New High School in Bungendore

State Significant
Development Application
(SSD-14394209)

Architectural + Landscape Design Report Addendum

Rev B
September 2022
Project No. 200096

17 Additional Community Parking

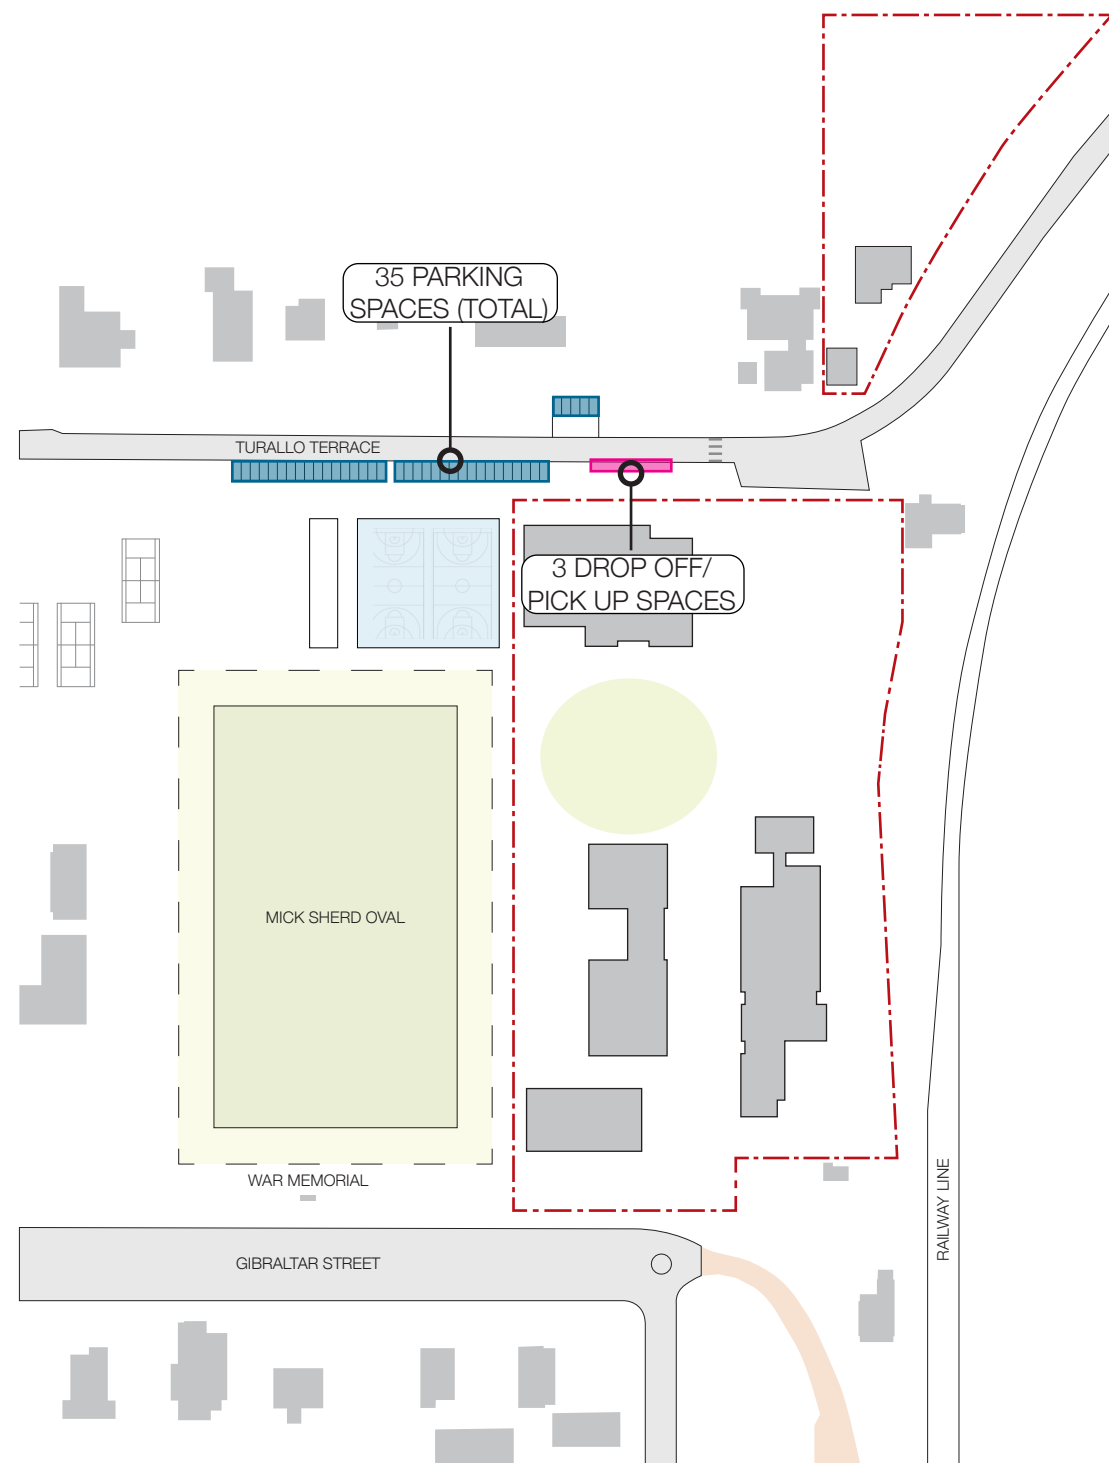
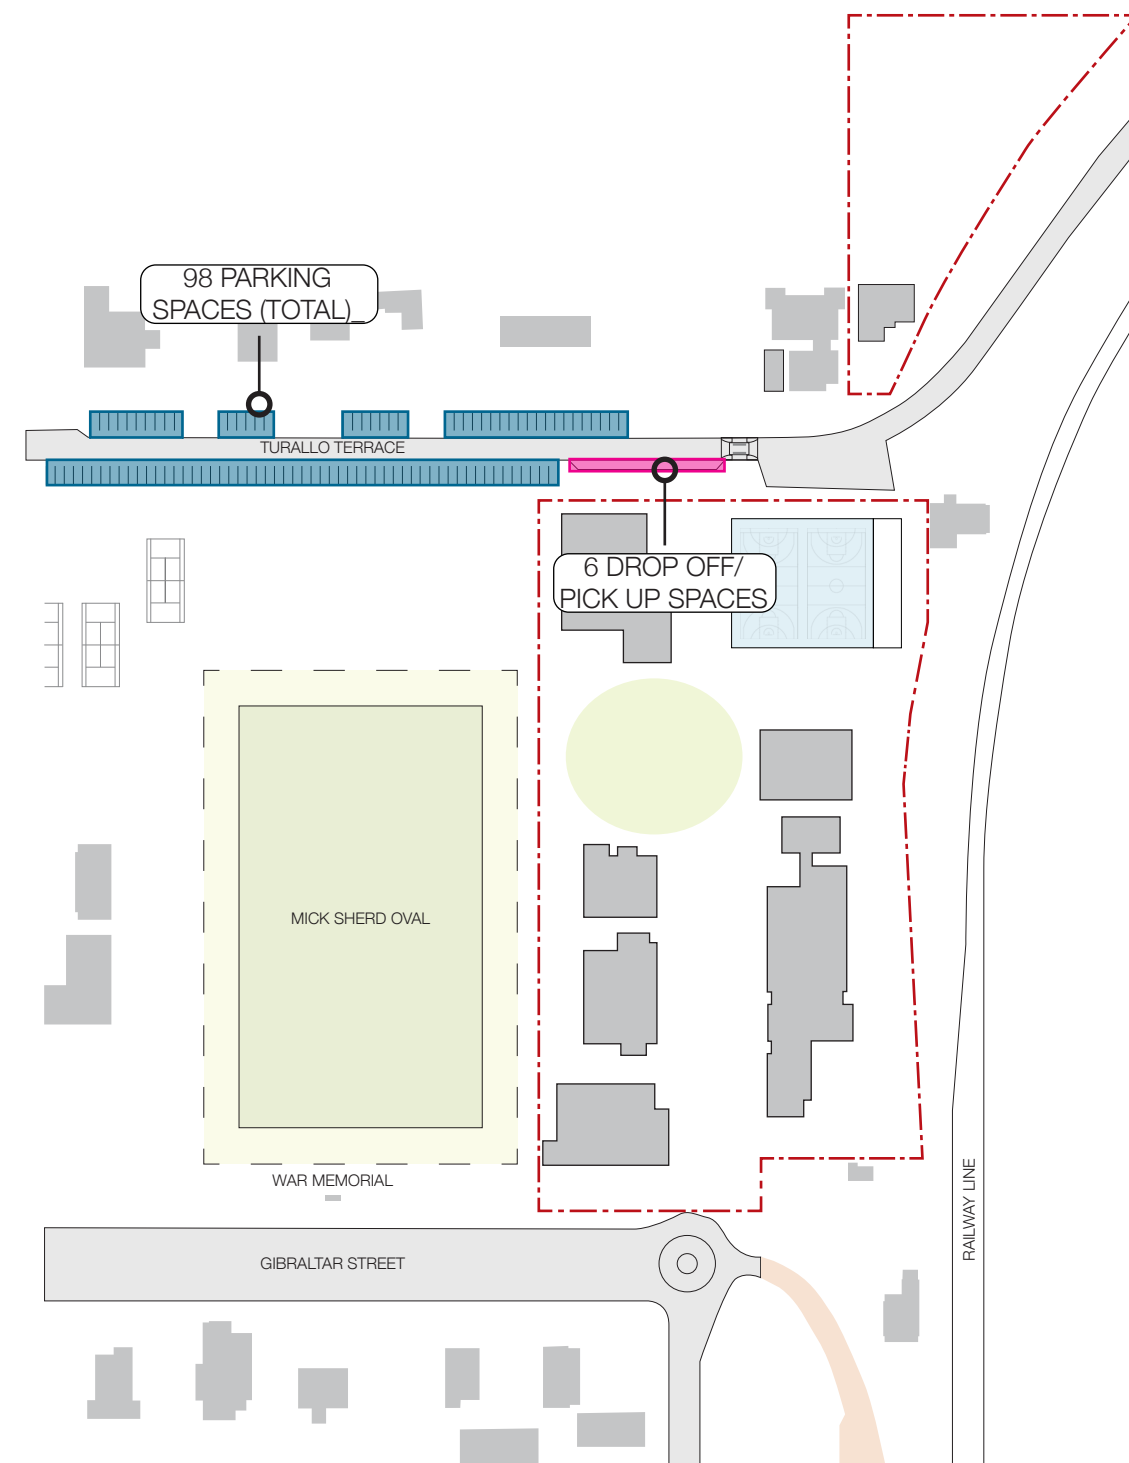
Consultation with QPRC, the Bungendore Scout Group, Bungendore Pre-School and a representative of the Signmans Cottage has been undertaken and the Authority's recommendation has been implemented in the design. An additional 58 parking spaces have been provided to Turallo Terrace. A total of 98 car spaces are provided to the street. The 3 dropoff and pickup spaces on Turallo Terrace have also been increase to 6 in reponse to Agency feedback.

18 Delineation of Mick Sherd Oval

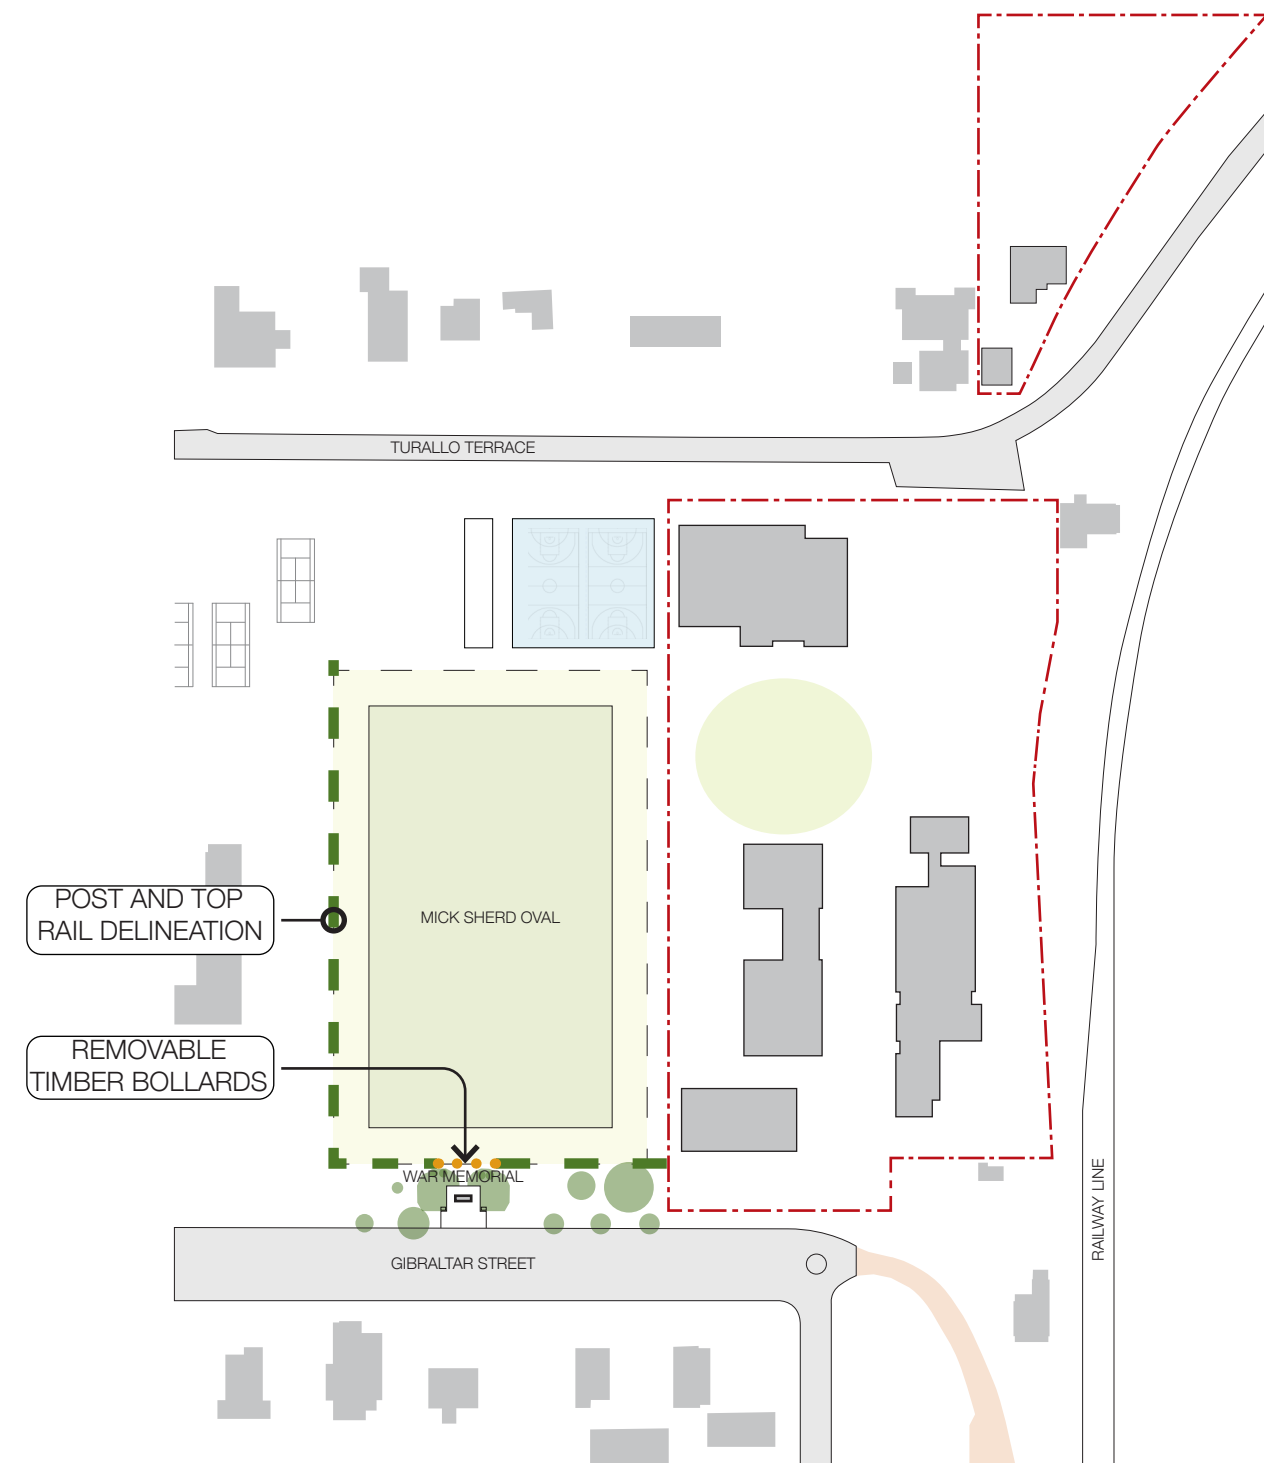
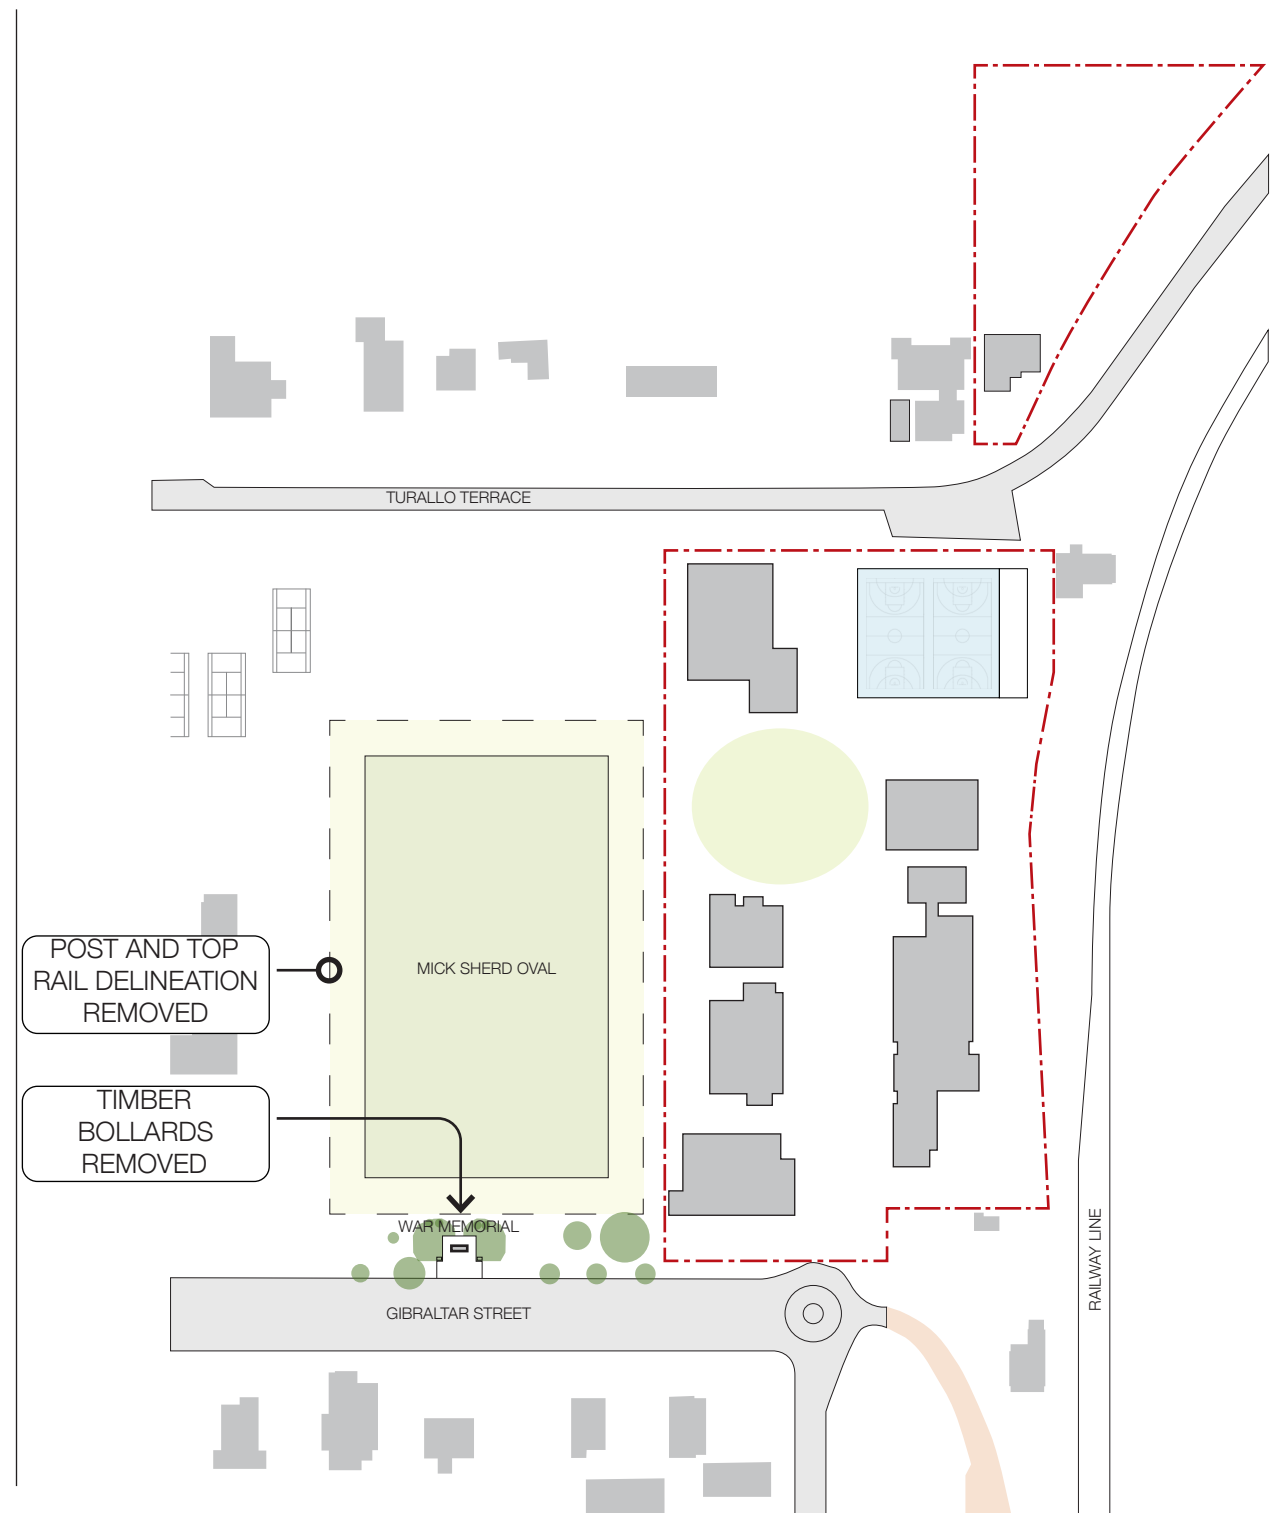
The post and top rail sports field delineation and removable timber bollards to the Mick Sherd Oval have been removed.

19 War Memorial Curtilage

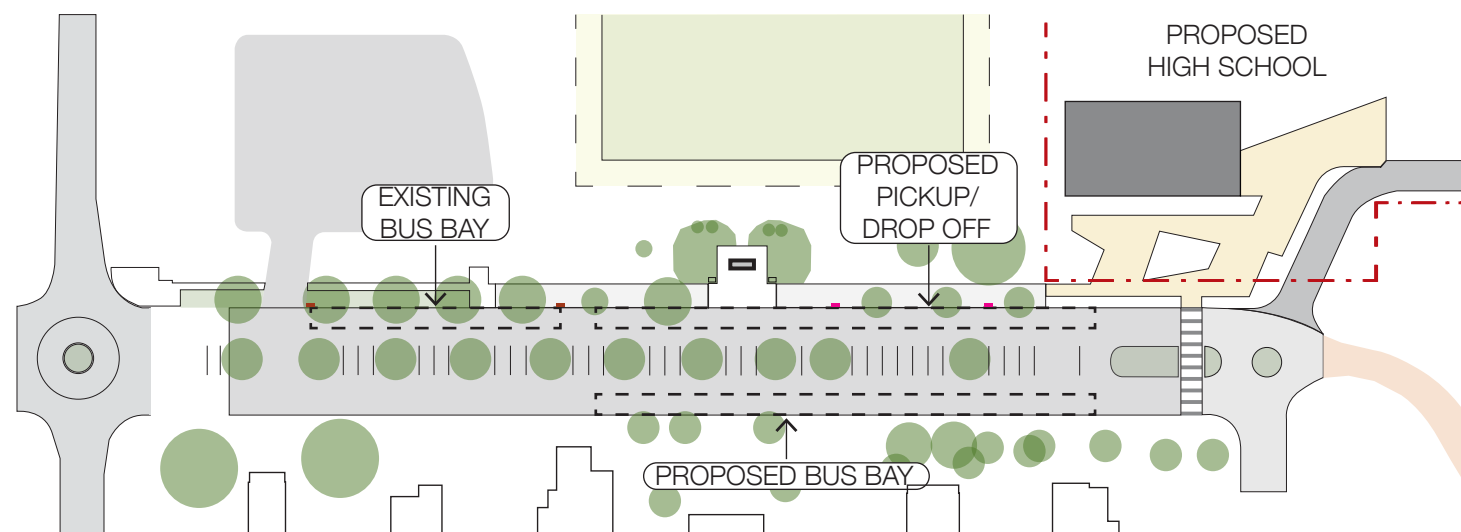
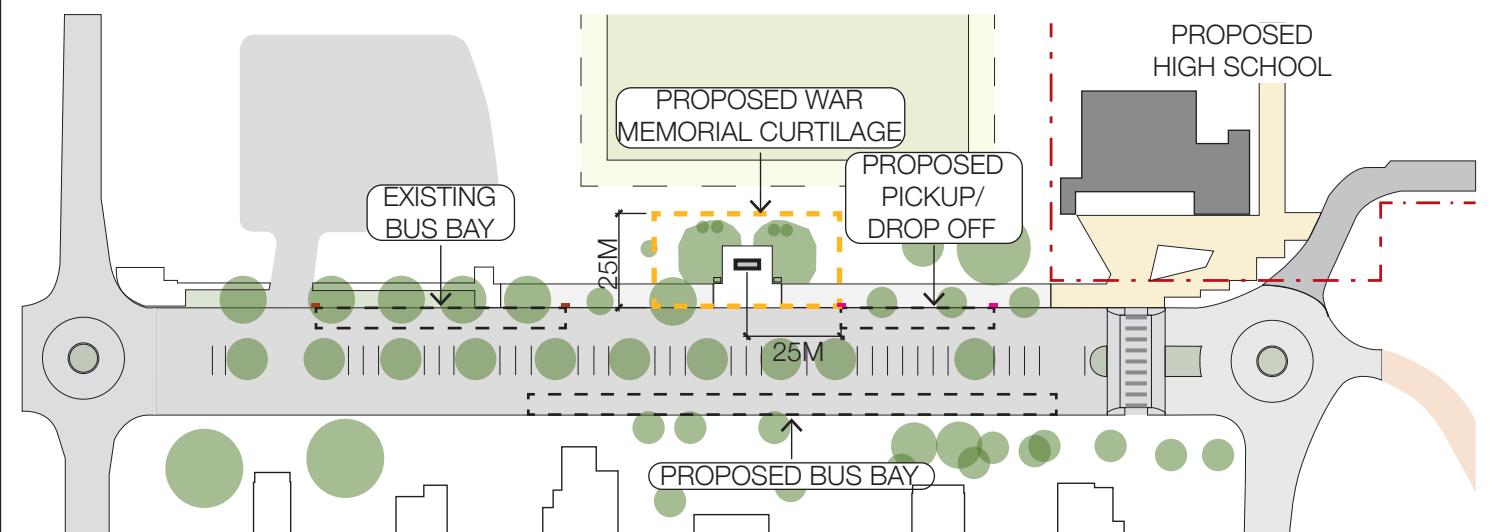
The Department has met with the BWMC to discuss the concerns raised regarding the proposed pick up and drop off zone fronting the War Memorial to agree on suitable amendments, where required.

- The extent of the kiss and drop to Gibraltar Street has been reduced to provide a 25m curtilage to the existing War Memorial. The proposed curtilage is 50 metres along Gibraltar Street kerb, centred on the arch, with a side setback of 25 metres as shown by the dashed orange rectangle below.
- The proposed post and top rail delineation and removable bollards around Mick Sherd Oval have been removed from the proposal.

20 Landscape Redesign

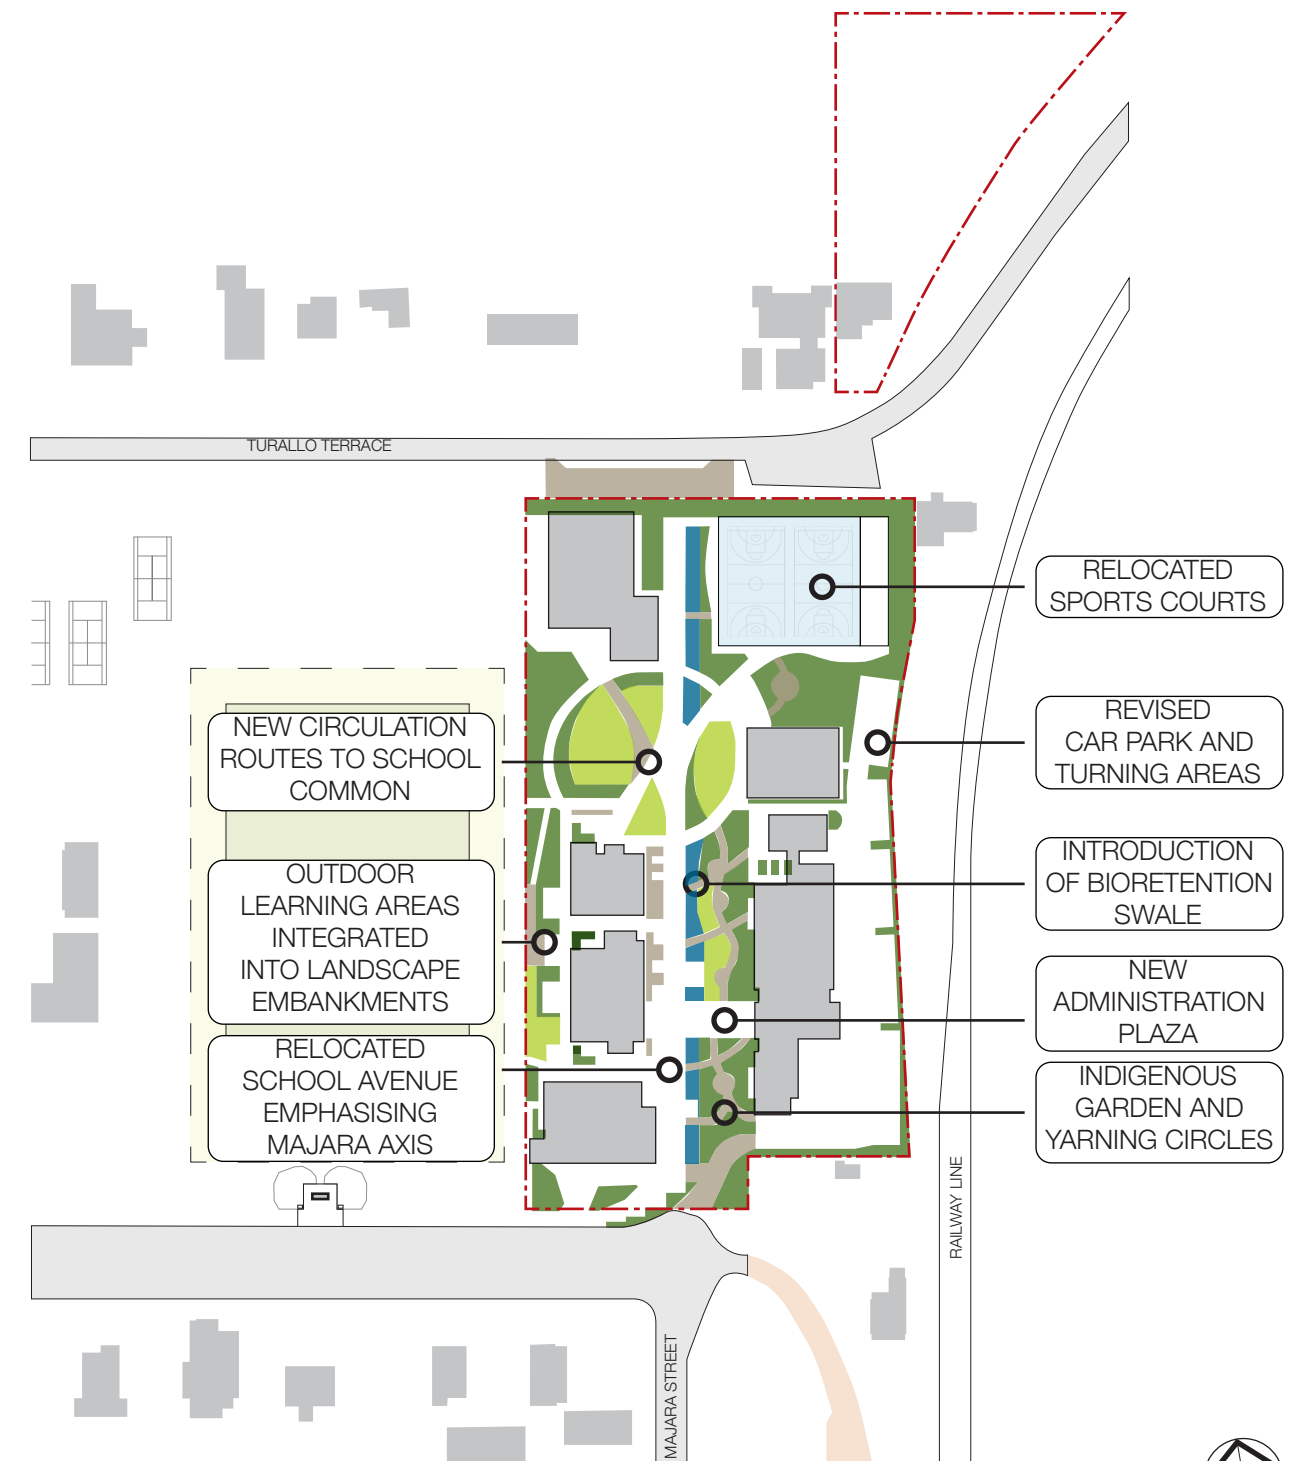
The landscape masterplan has been redesigned in response to GANSW comments and to complement the architectural amendments.
